CASE No. 2020-00219
AEUG MADISON SOLAR, LLC
RESPONSES TO WELLS ENGINEERING'S FIRST REQUEST FOR INFORMATION

Electrical One-Line Diagram

XXXX-DWG-HVS-101-000003

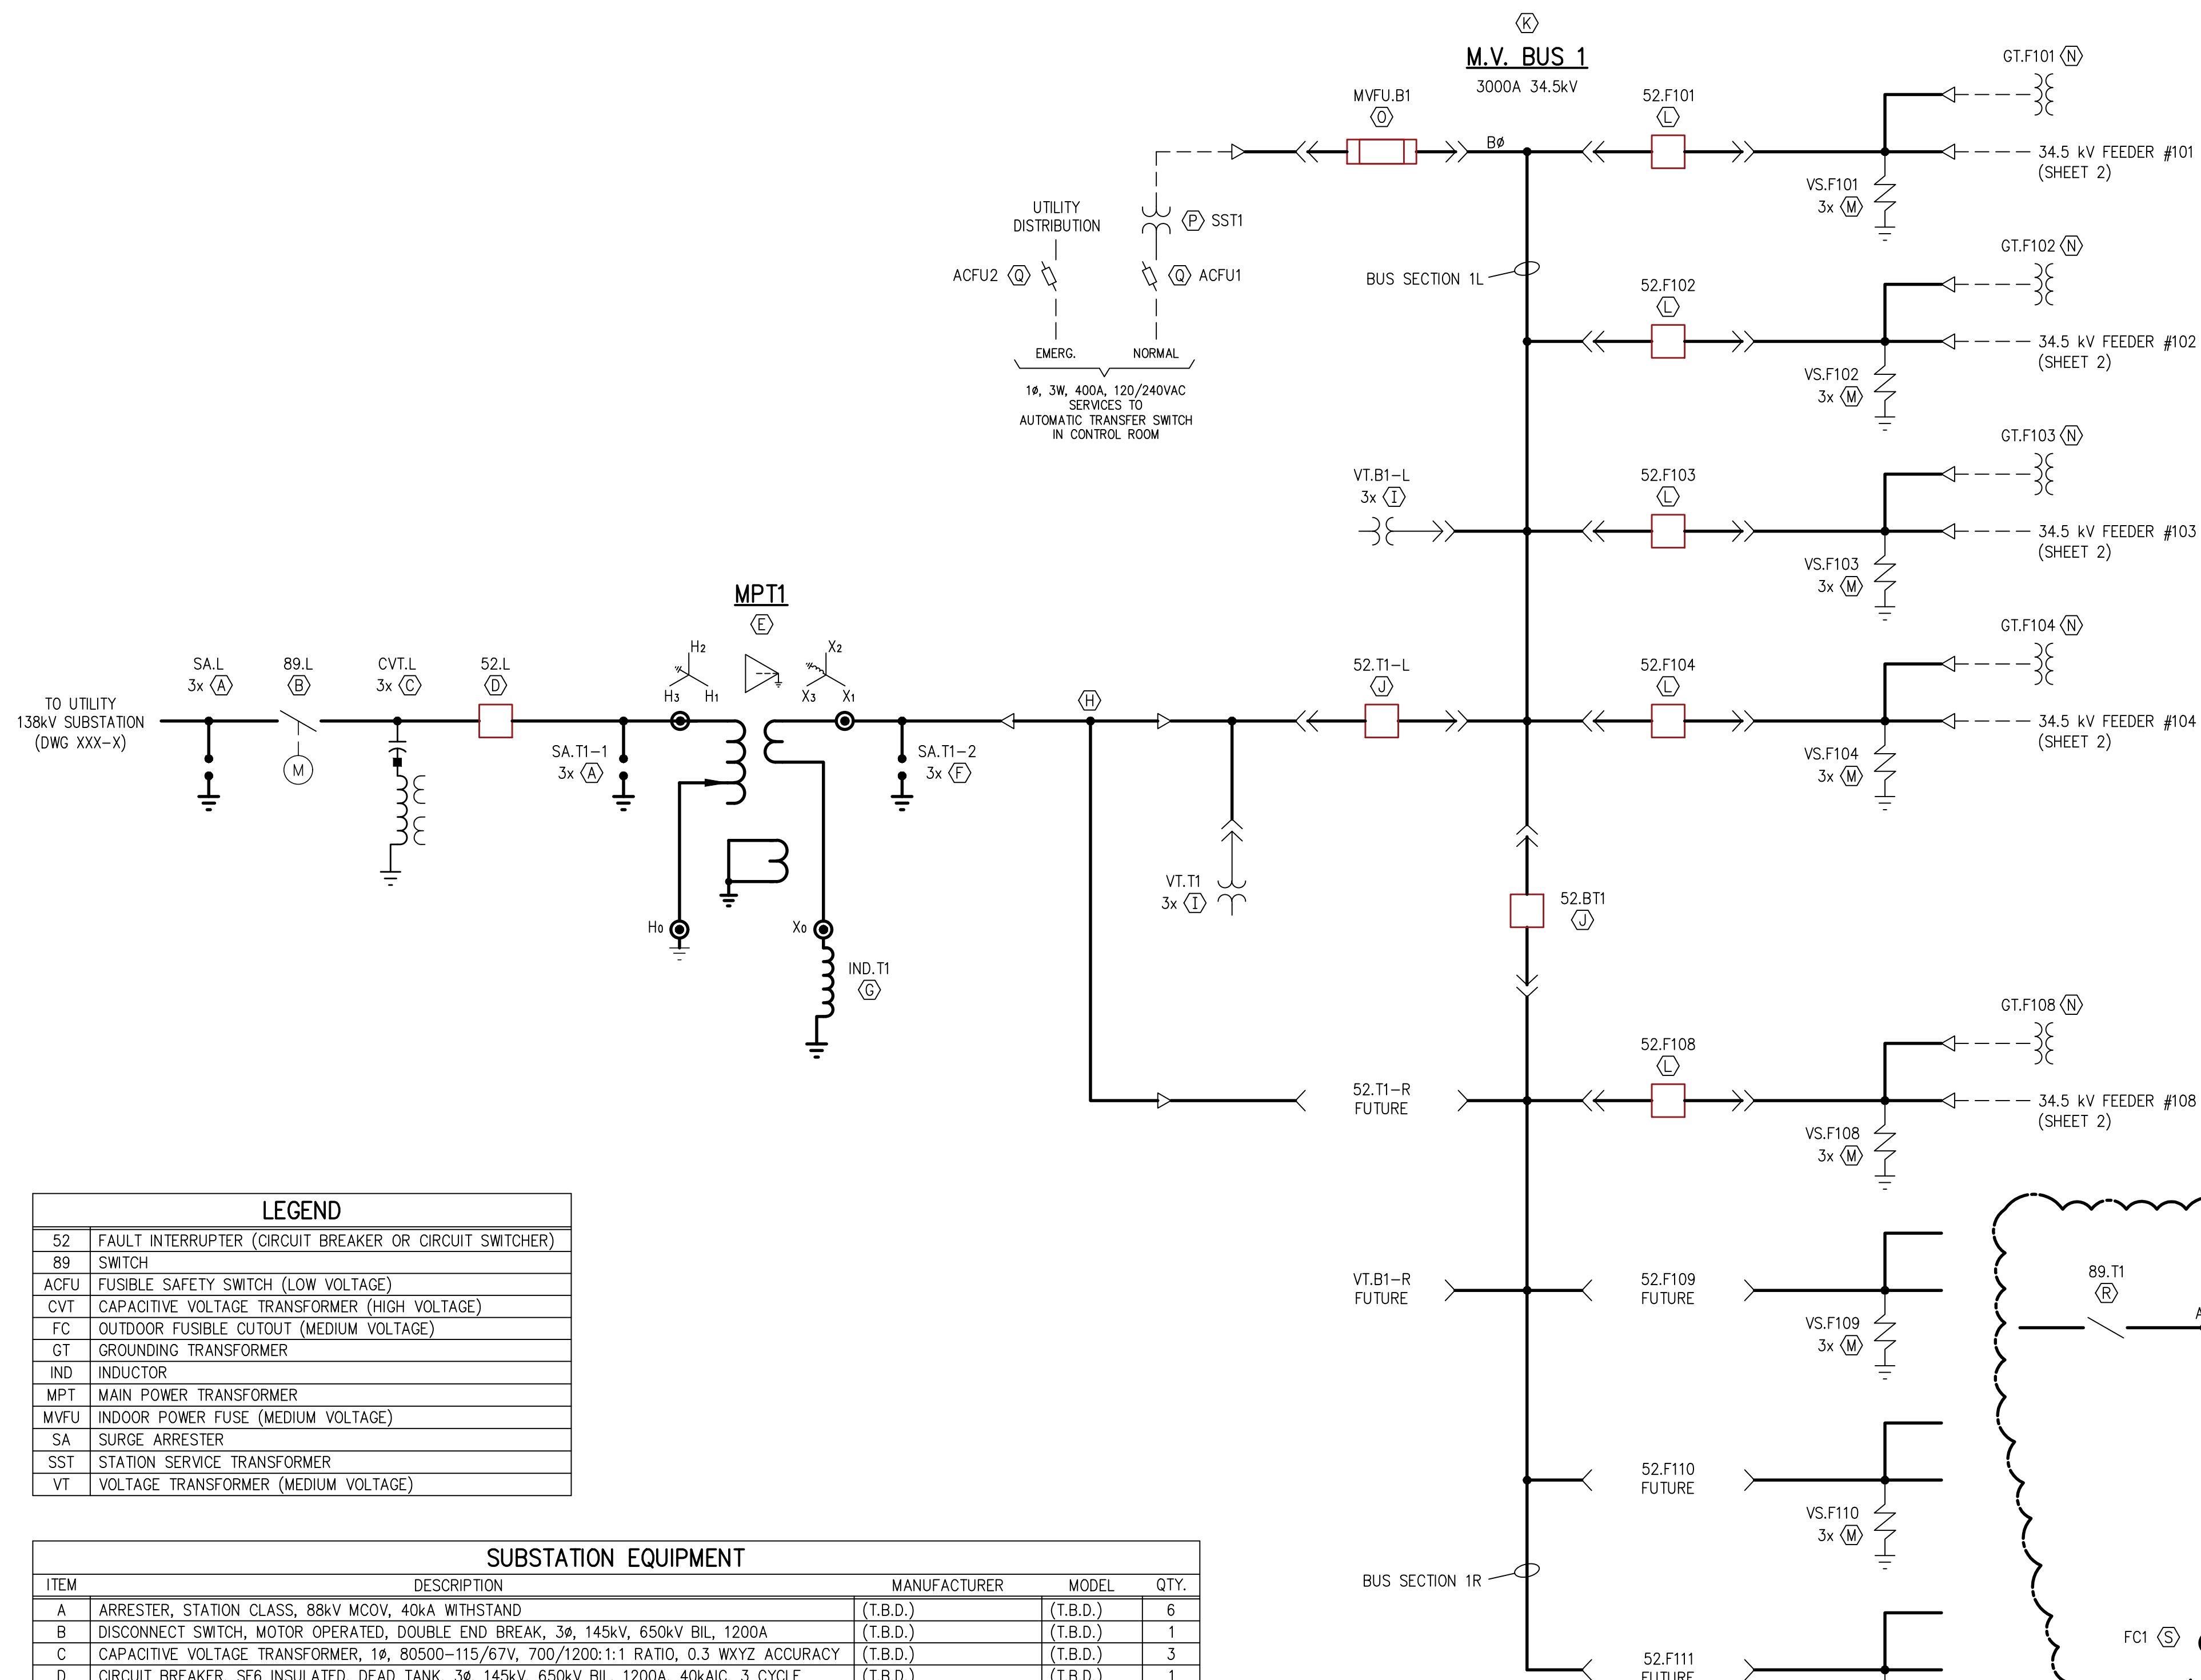
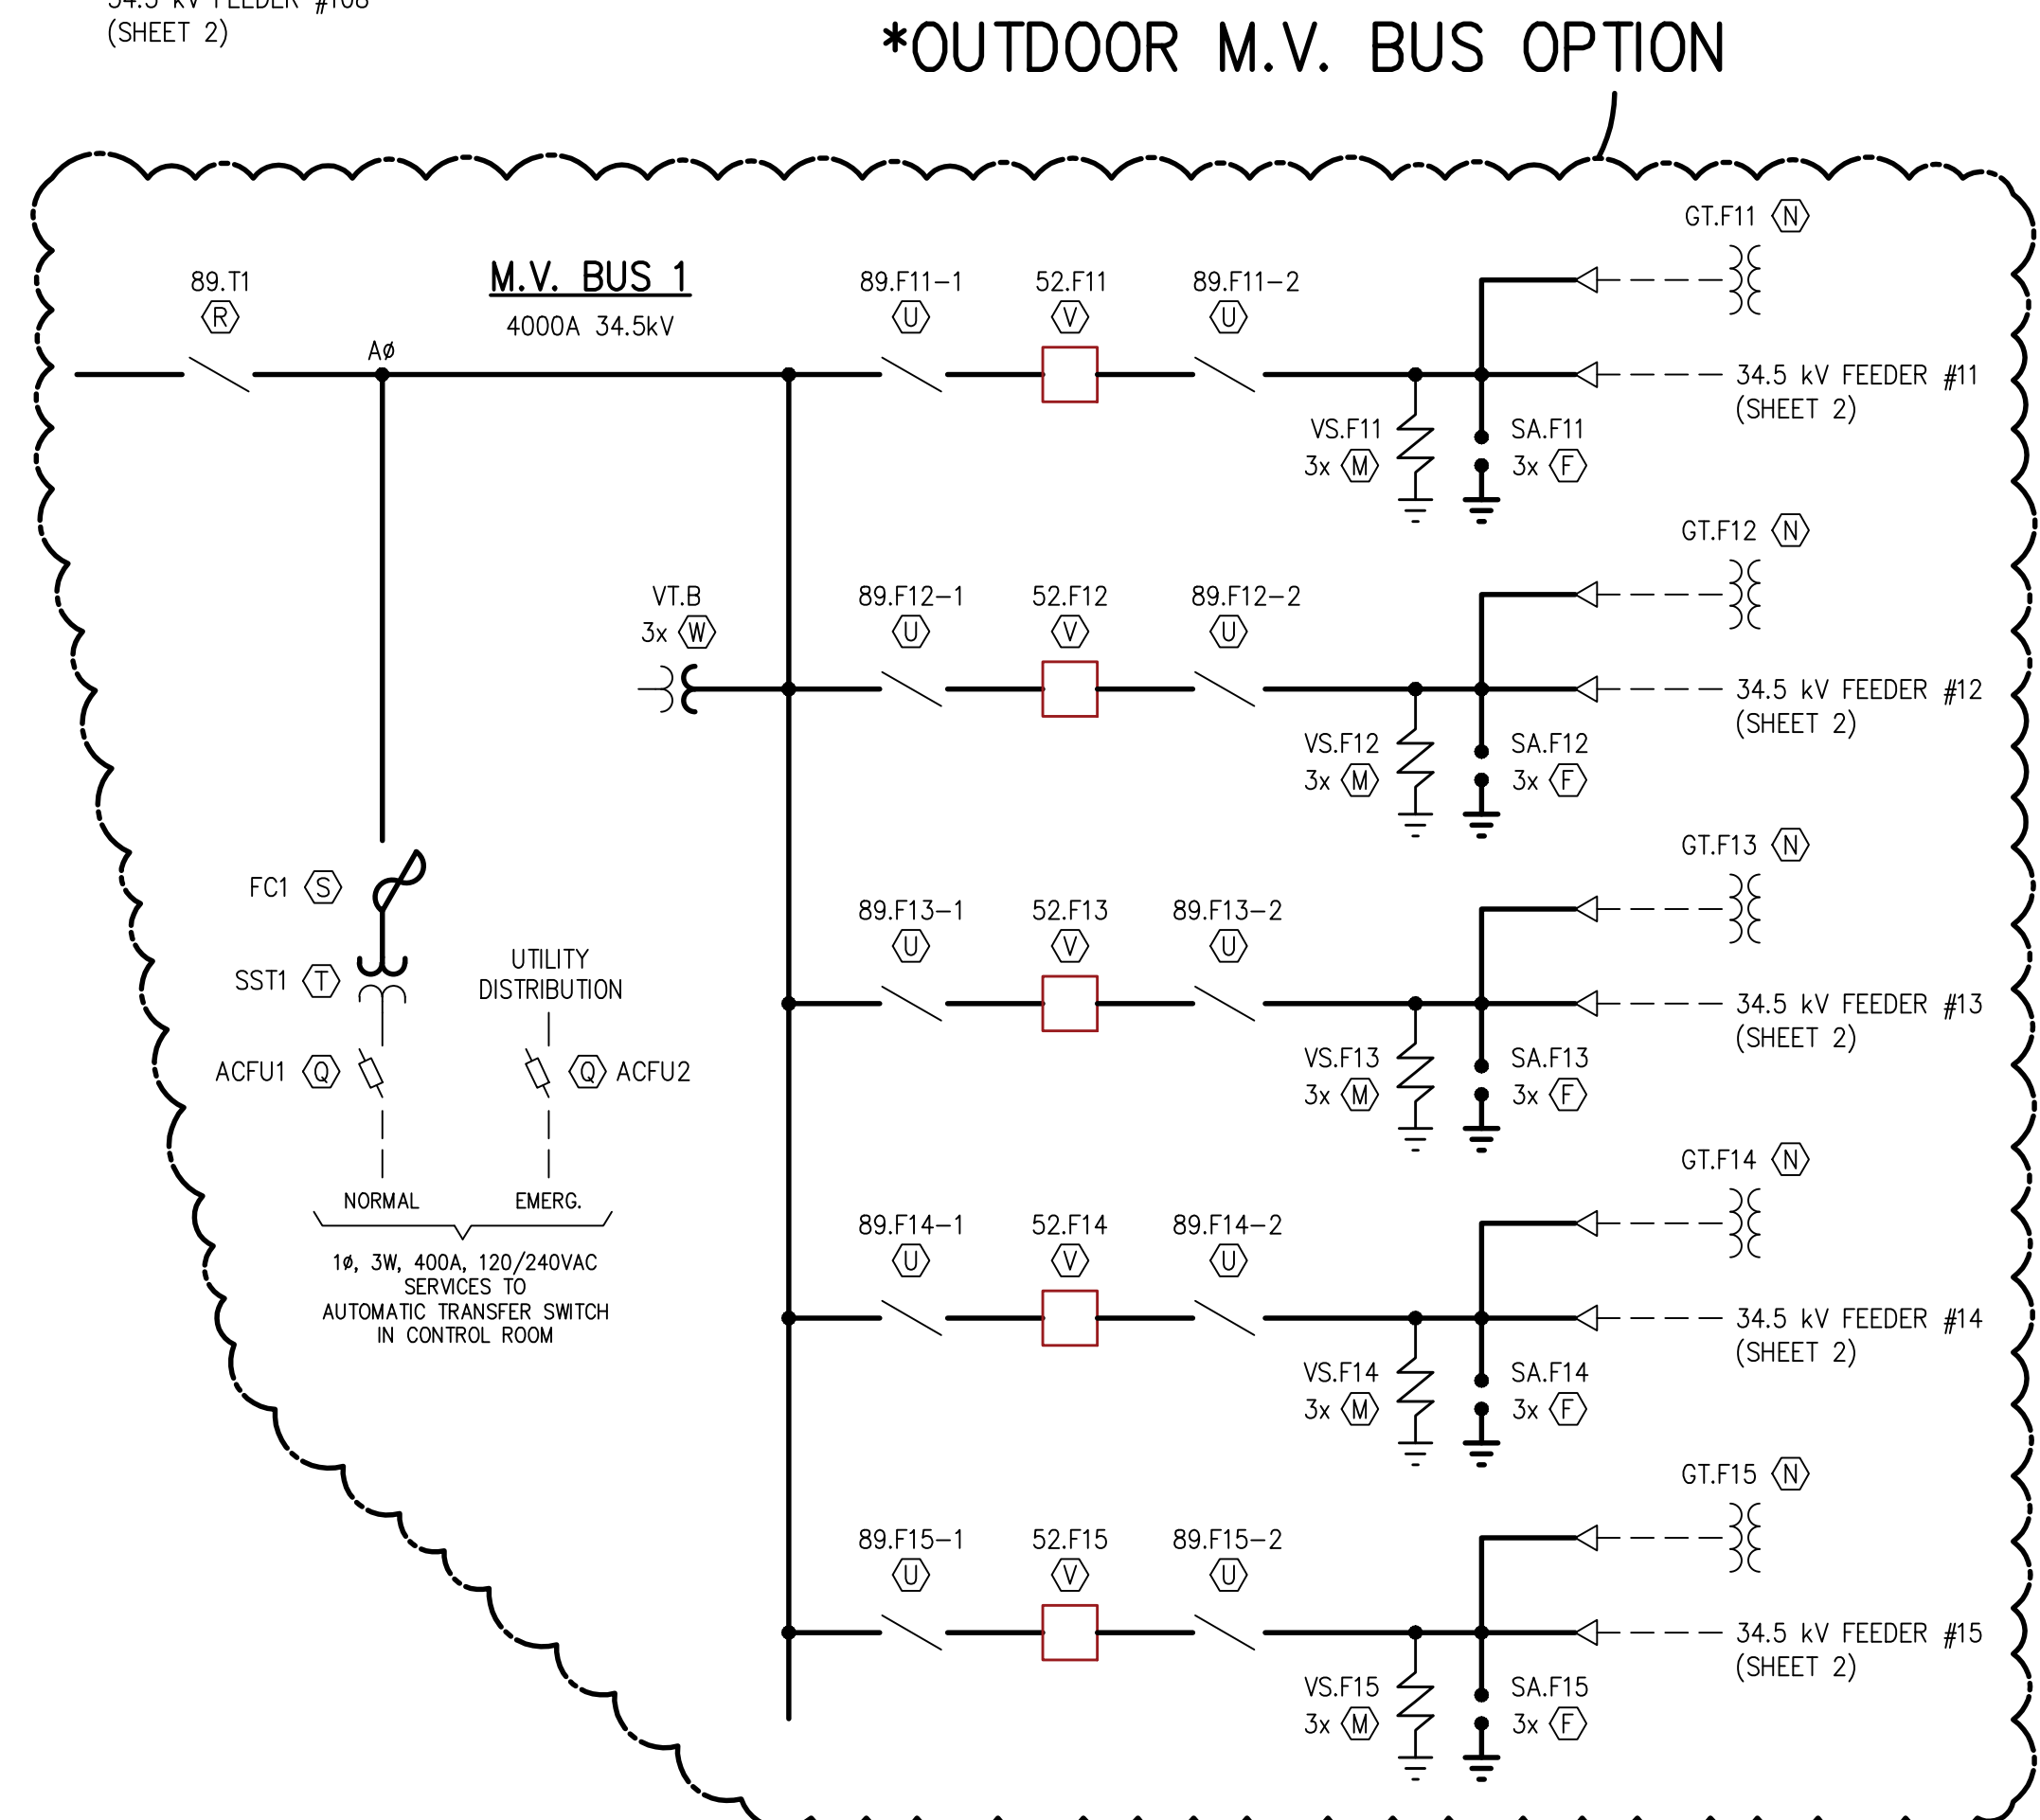
Question#1

Electrical One-line diagram is very important document required for understanding and evaluating the Electrical Power Network and Interconnection.

Applicant to submit Electrical One-line diagram of the installation.

RESPONSE: See attached document.

RESPONSE: The only transformer that falls under DOE efficiency requirements is station service (item P on the single-line diagram, see response to question 1 above). This transformer will comply with DOE requirements.
